HISTORIC DISTRICT REVIEW BOARD

Wednesday, January 14, 2026, 2:00 P.M.

STAFF REPORT: Historic District Review Board (HRB)

1705 DUKE STREET

1 NORTH ELEVATION

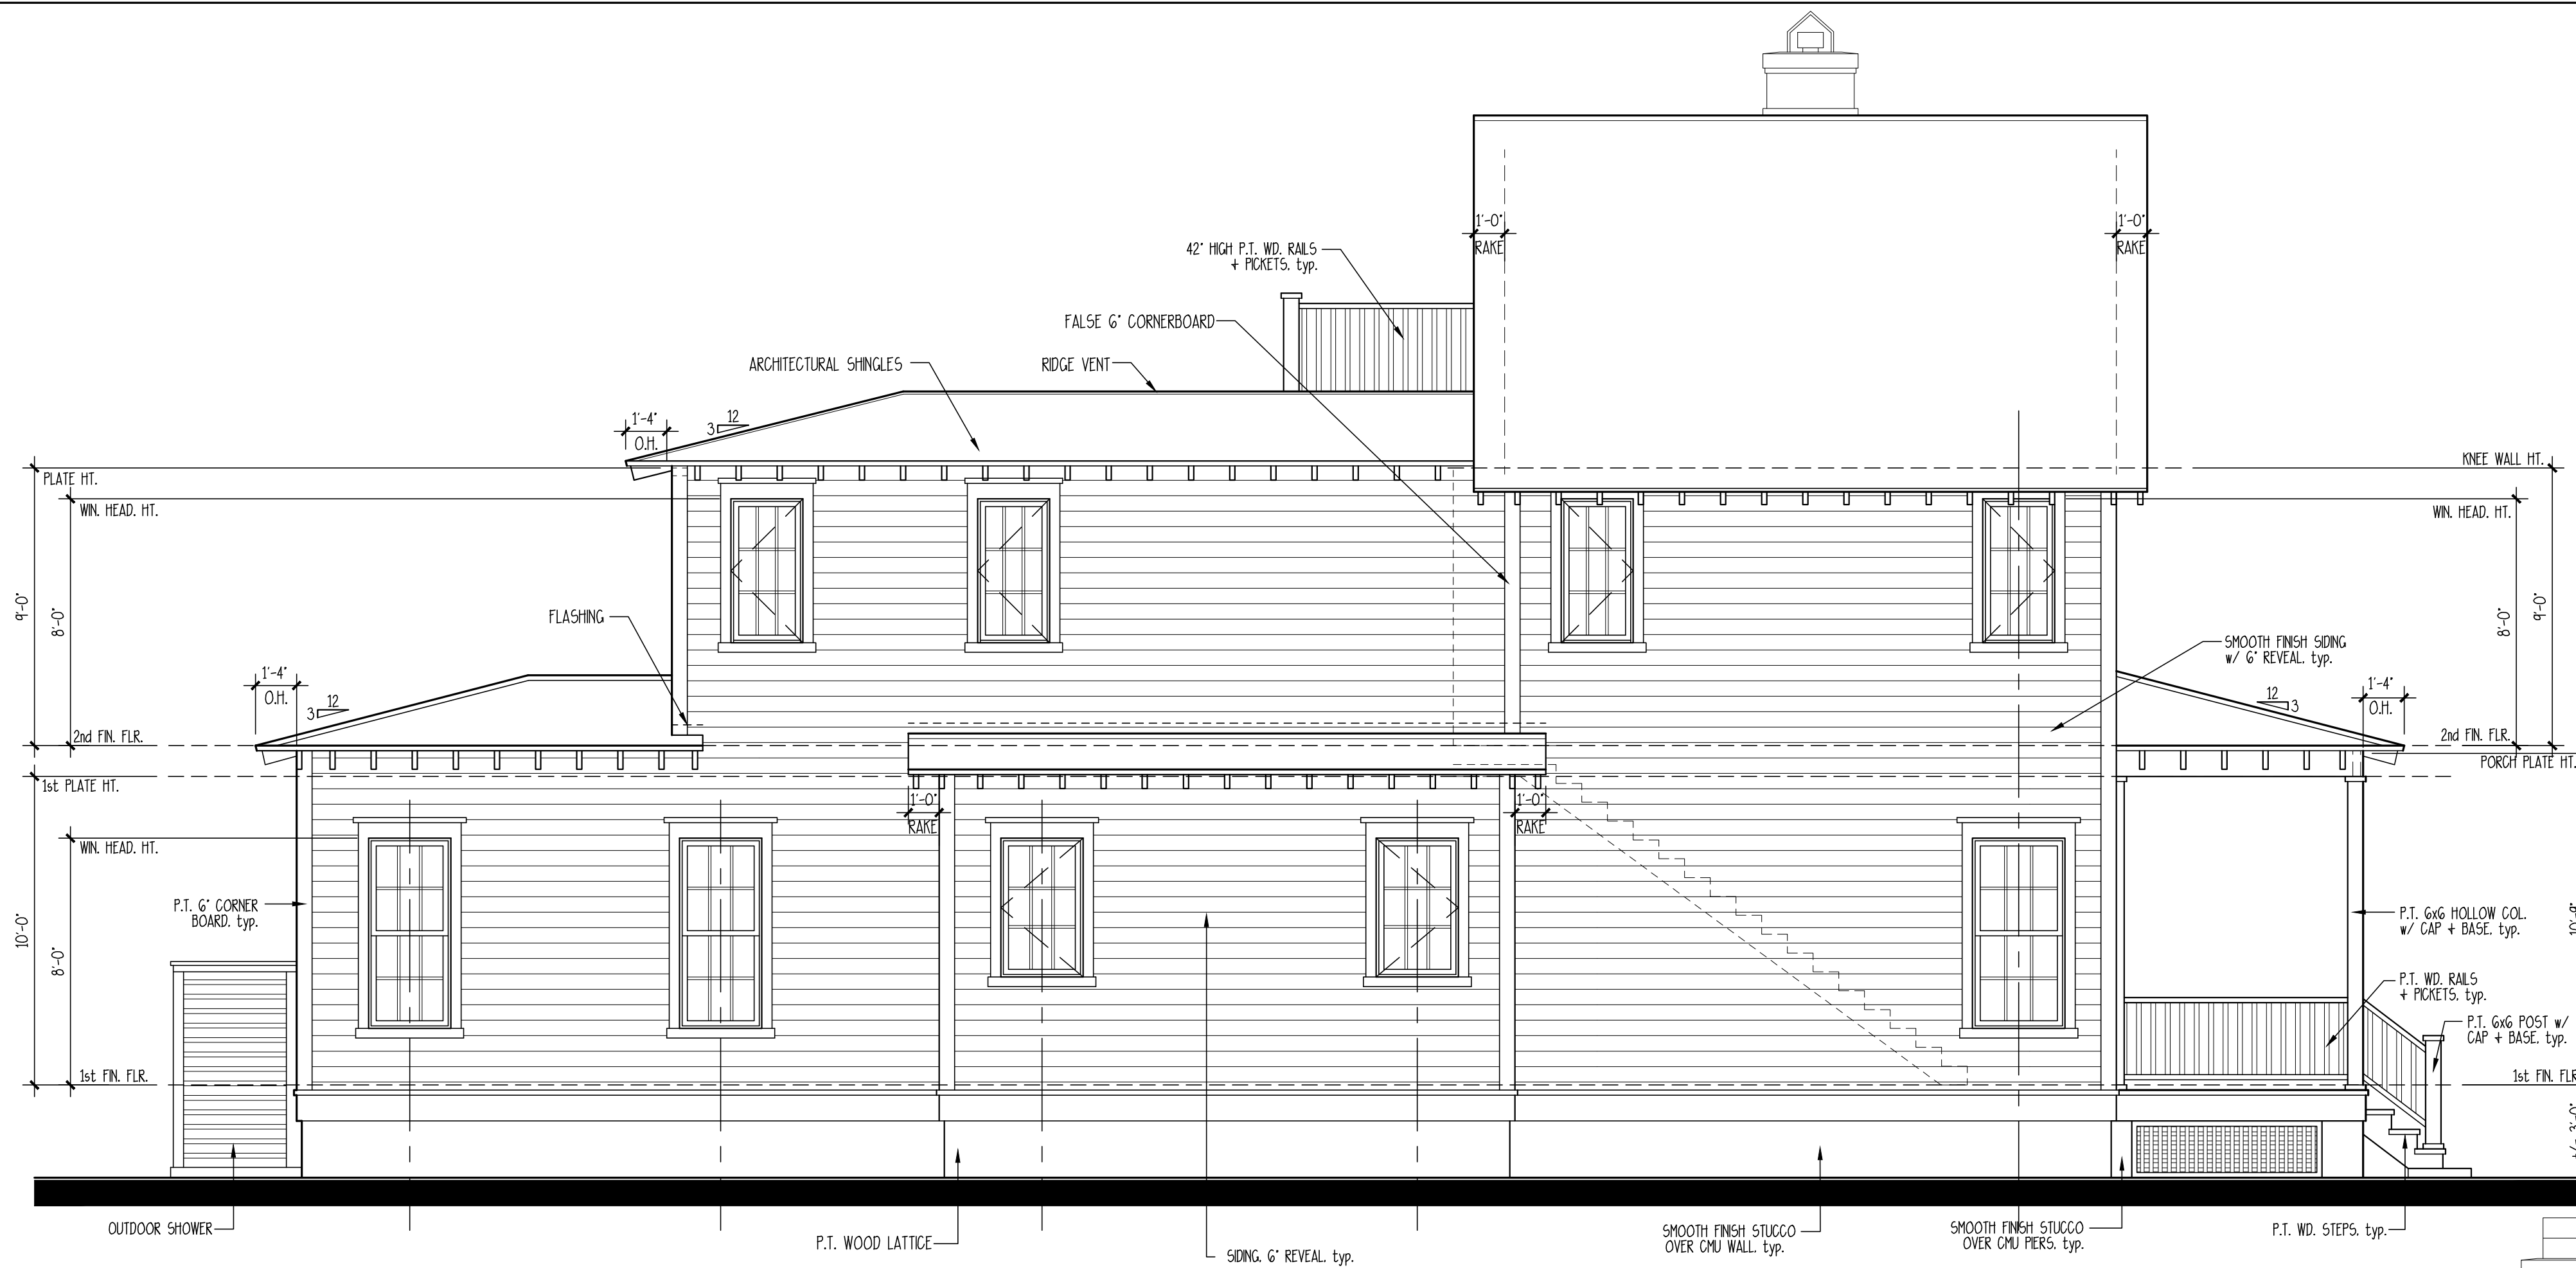
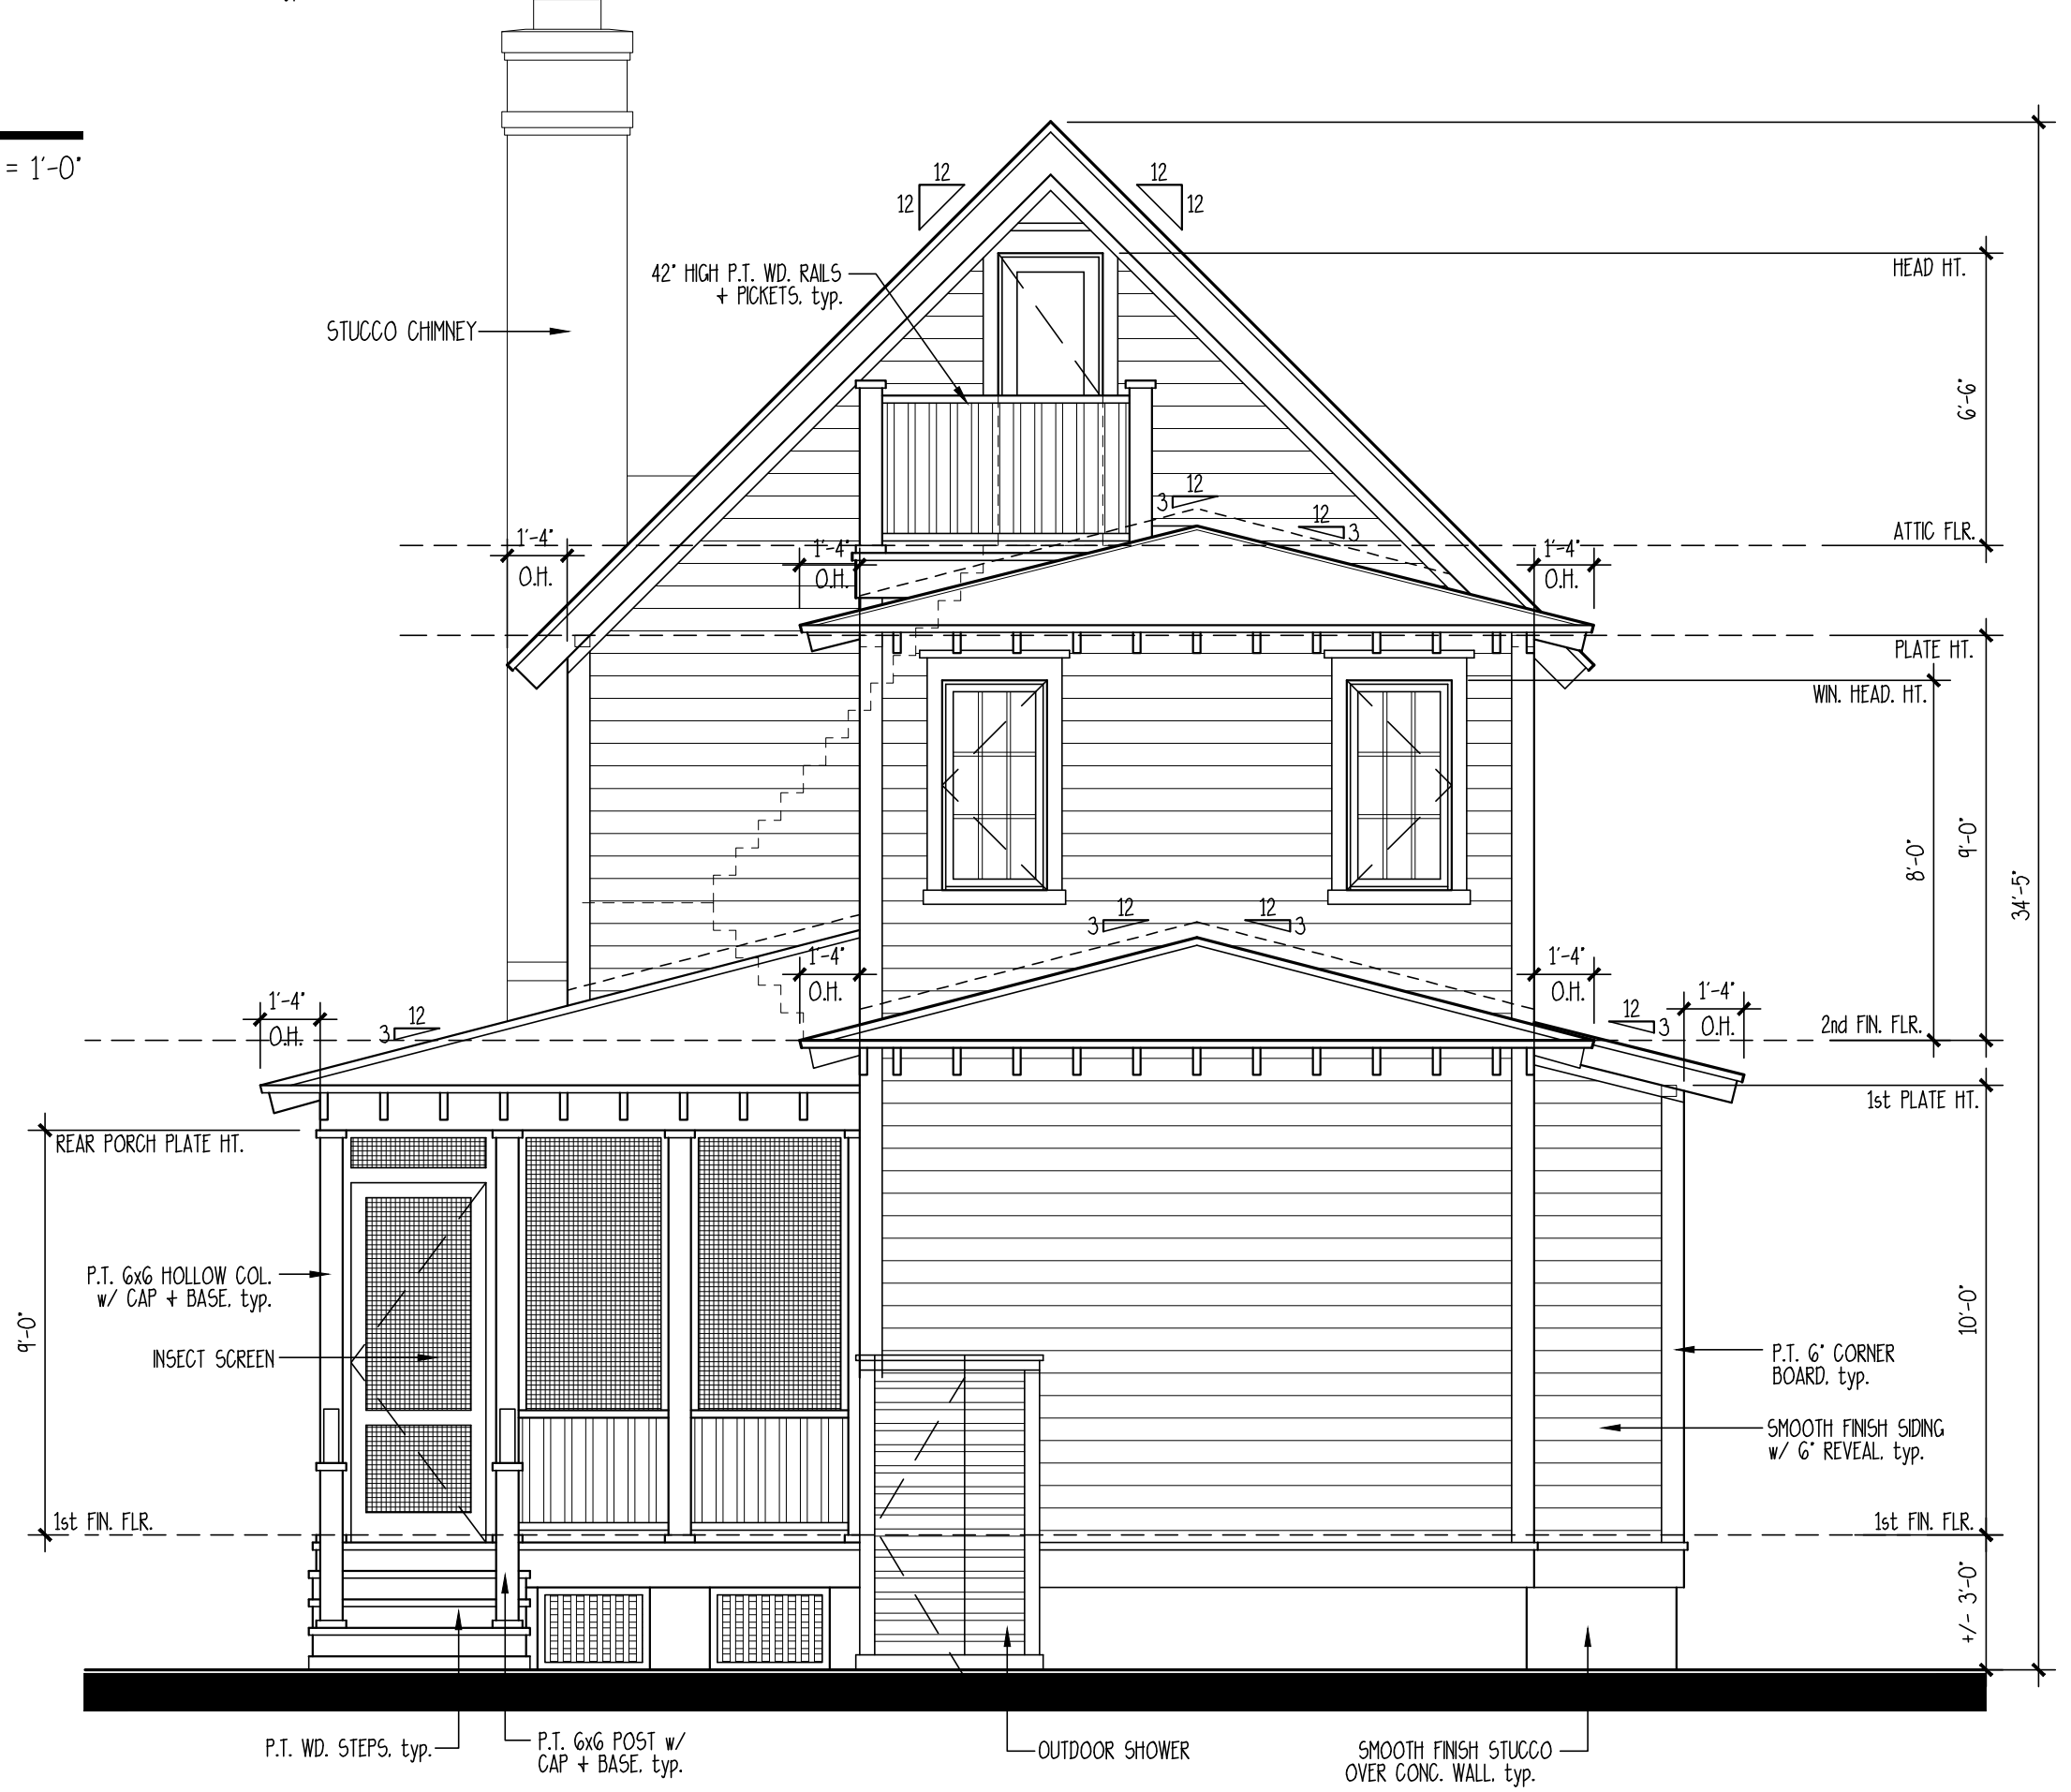
4. Staff is supportive of a two-story structure on this site but recommends reducing the slope of the main roof from 12/12 to 11/12 or 10/12 to be more sensitive to the height of the existing structures on the block. HDRB has furthermore approved a motion that includes the recommendation to restudy the slope of the roof between a 12/12 and 10/12 pitch. Staff would recommend to present a comparison between the two slope scenarios for the next HDRB Meeting for final approval. (the change to a 10:12 slope already has been implemented with the latest HDRB submission). **Applicant has not changed**

the slope of the main roof; it remains to be 12/12. Secondary rooflines (front & rear porches) are 3/12.

4 TYPICAL WINDOW SILL

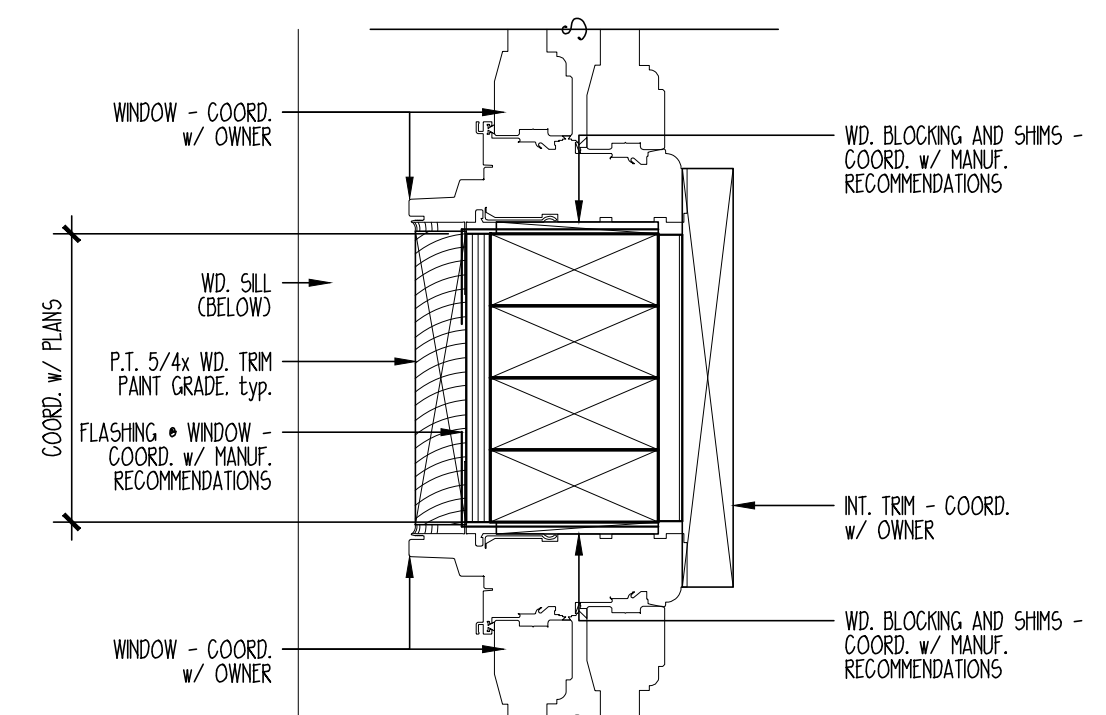
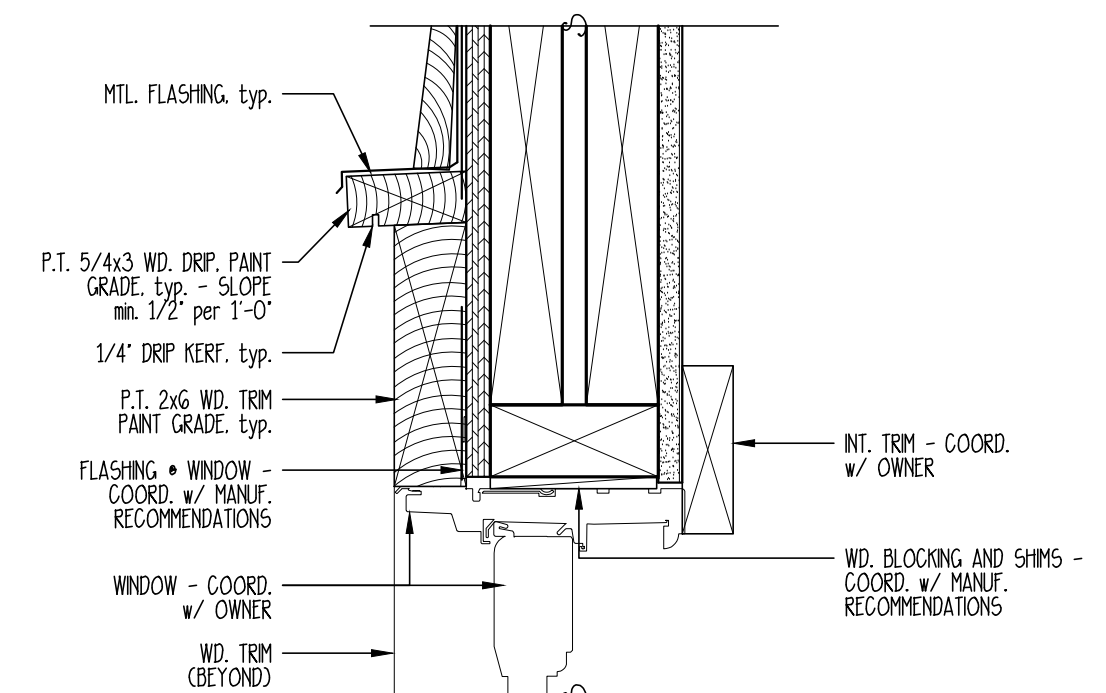
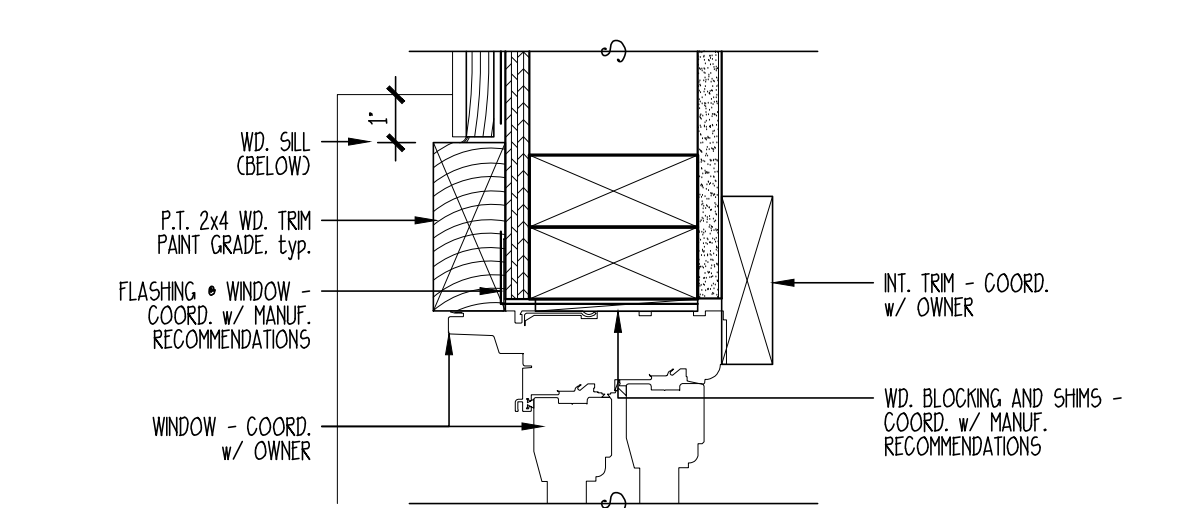
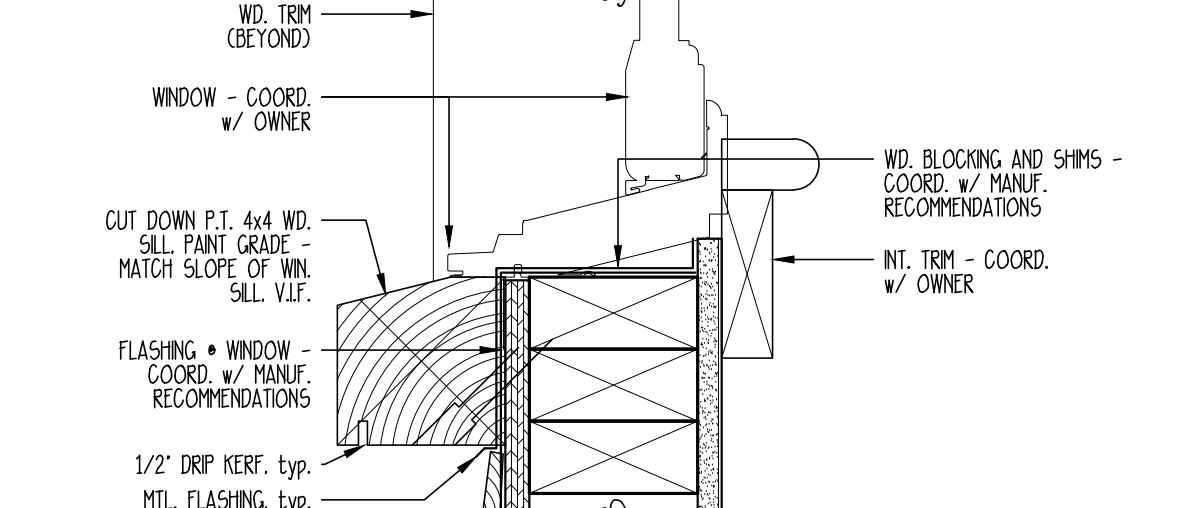
6. Applicant to label all materials and provide detail drawings, including:
 - a. Door details
 - b. Window details – note windows must have a projecting sill per section 4.6.3.C.2.a.
 - c. Railing details
 - d. Gable vent details
 - e. Eave/rake details
 - f. Typical wall sections at the house and ADU (including a section through the main house porch).
7. Applicant to provide cutsheets/information for the following:
 - a. Windows
 - b. Exterior doors
 - c. Garage doors
 - d. Exterior lighting/fans
 - e. Columns/railings if not wood
 - f. Paint colors for all exterior elements

- a. Door details; **has been submitted, see plan sheet #3 (items 1 thru 3)**
 - b. Window details – note windows must have a projecting sill per section 4.6.3.C.2.a.; **has been submitted, see plan sheet #4 (items 4 thru 7)**
